WILLIAMSON COUNTY, TEXAS

CHANGE ORDER NUMBER: 7

Project:	***13IFB00108***
Roadway:	***IH 35 NBFR***
CSJ Number:	***0015-08-128, etc.***

IH 35 Northbound Frontage Road
Williamson County Project No. 13IFB00108

ILLUMINATION SHEETS

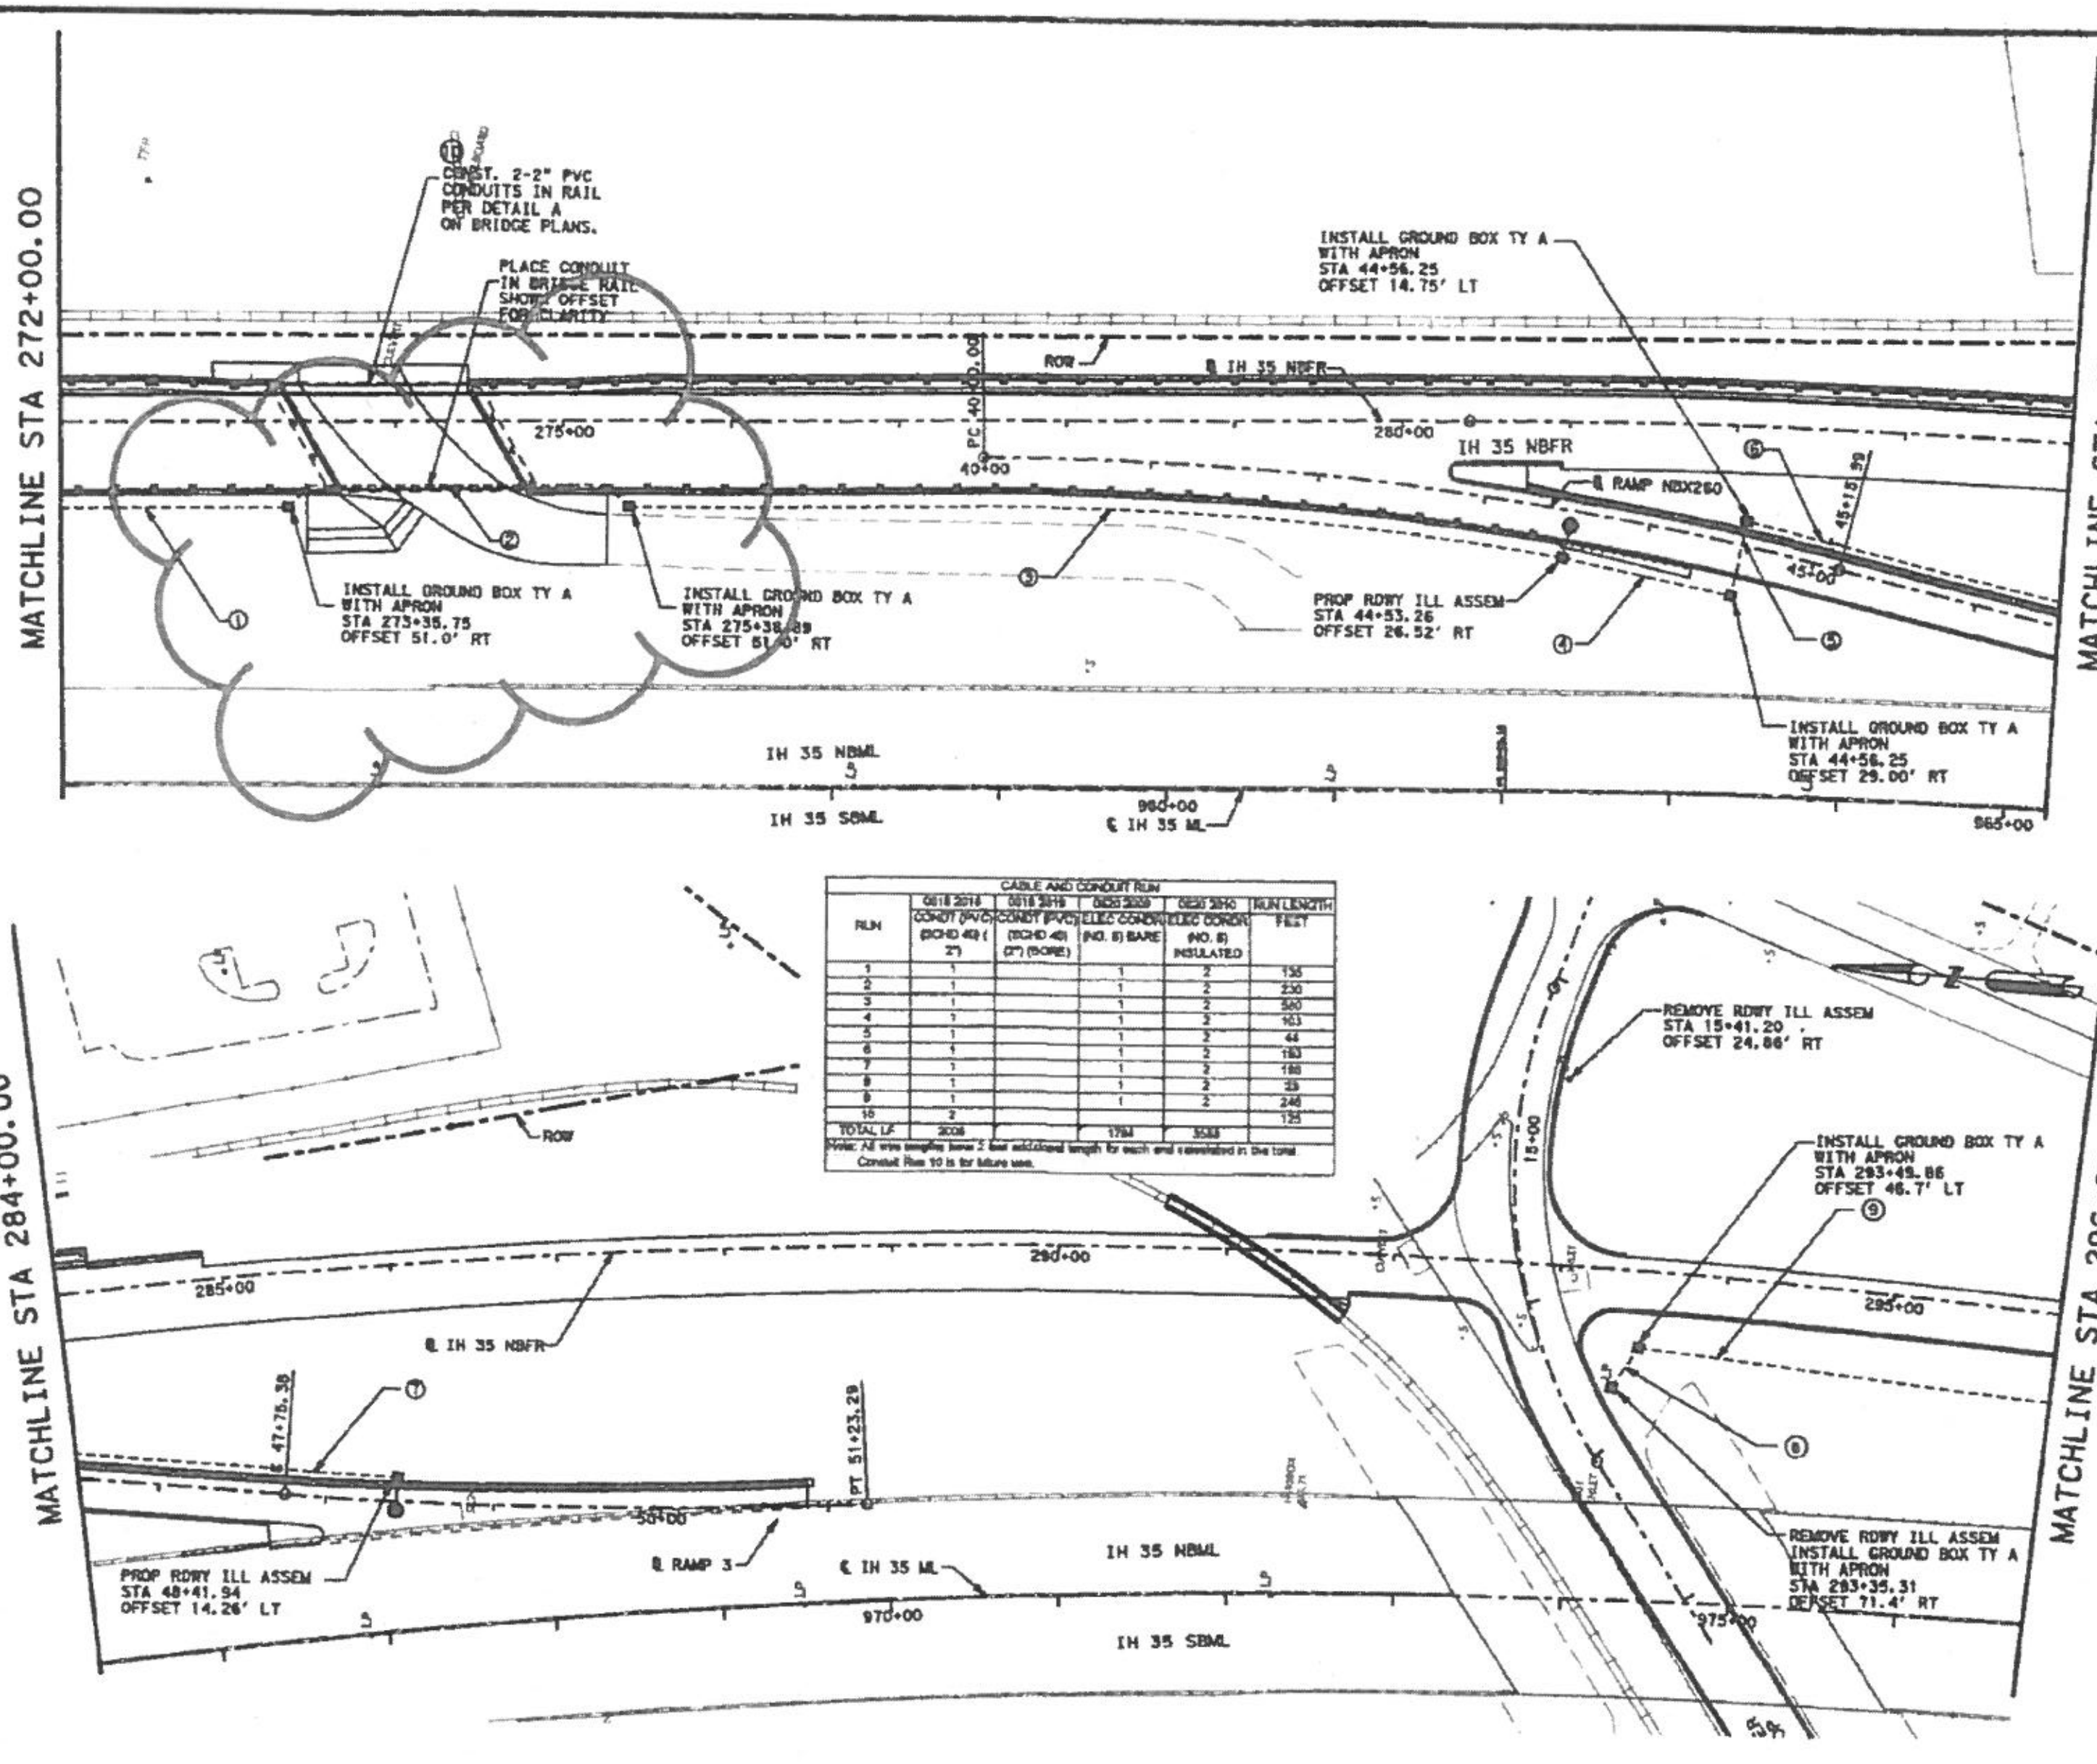
We offer the attached field change pricing to address issues with the illumination and future conduits to be installed inside the bridge decks at the three bridges (San Gabriel, W. Fork Smith, SBNB T/A bridge). These issues have been discussed with Clayton Weber of HNTB. The issue is the plans did not address how the conduits would exit the bridges and where the conduits would terminate. We propose to install them in the manner shown on the attached drawings and terminate the conduits in Type A ground boxes. We have also attached a conduit summary table that accounts for all of the bridge conduits. Finally, we have attached a summary table detailing the quantity overruns and new bid item needed due to this change.

SBNB T/A BRIDGE LAYOUT

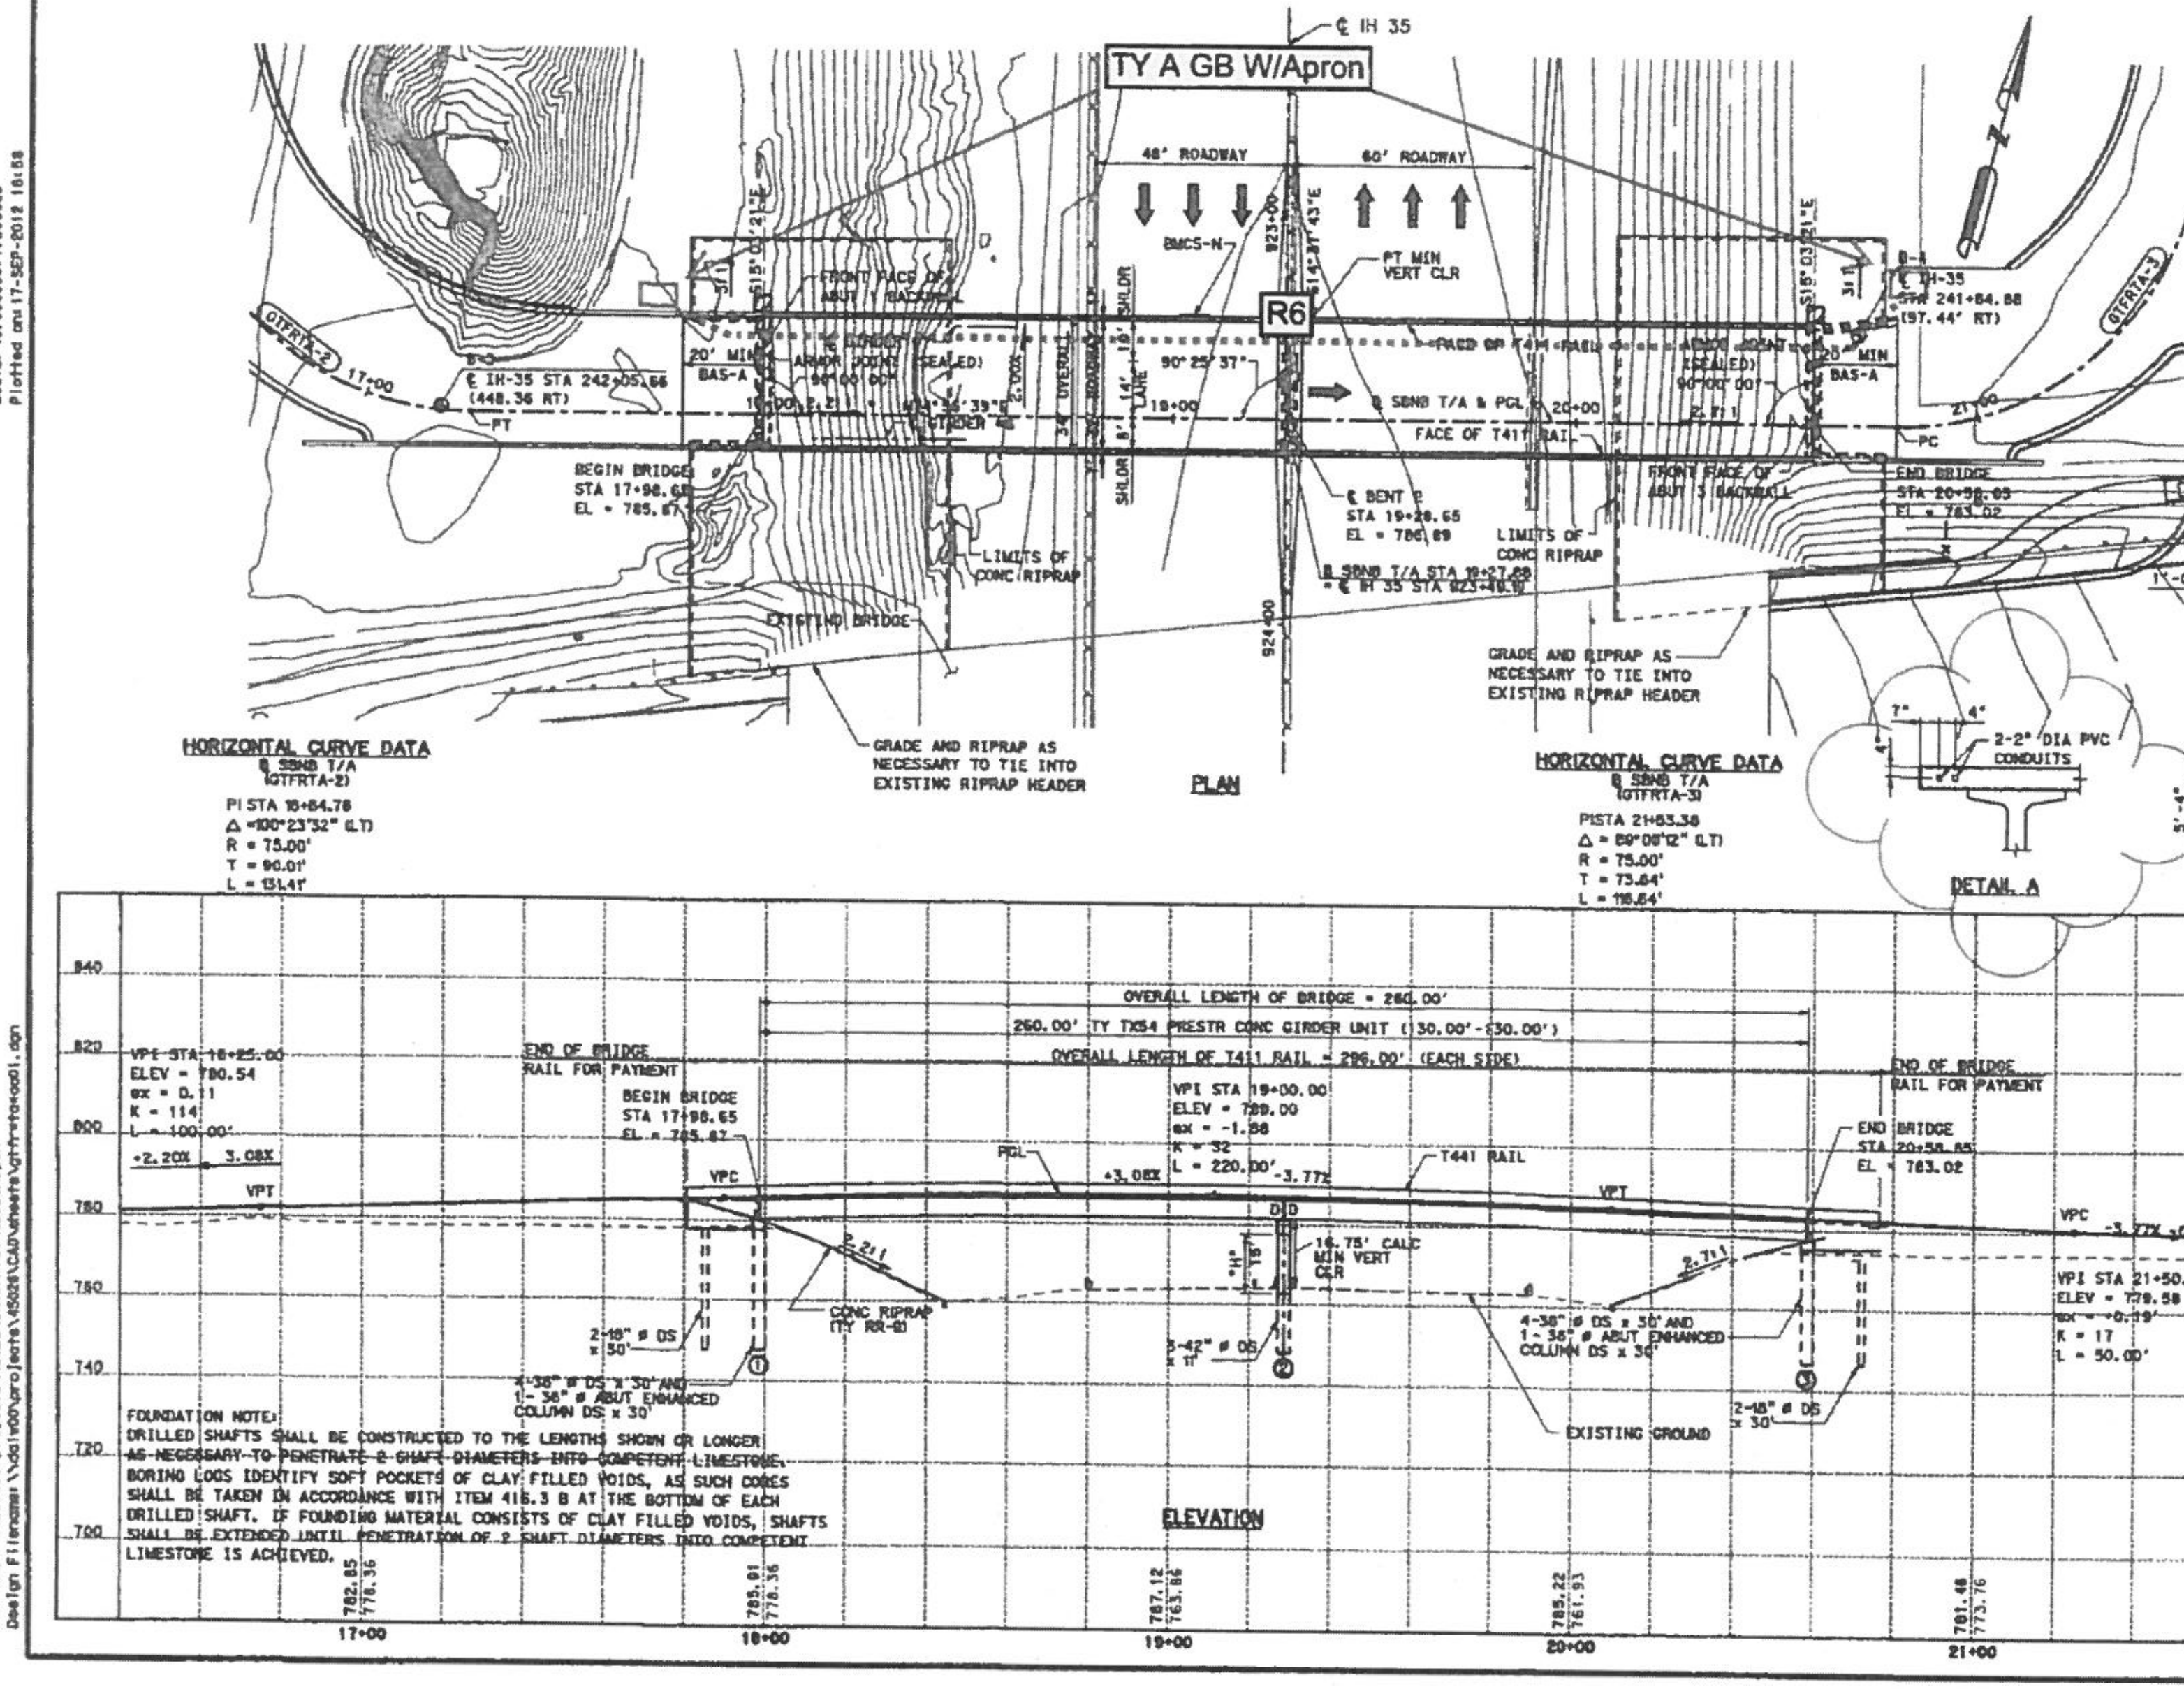
This Change Order also adjusts 2" PVC conduit and Type A ground box quantities and adds a Type 1 ground box item that were intended to be constructed in the original plan set per the bridge layout typical sections but were inadvertently not quantified.
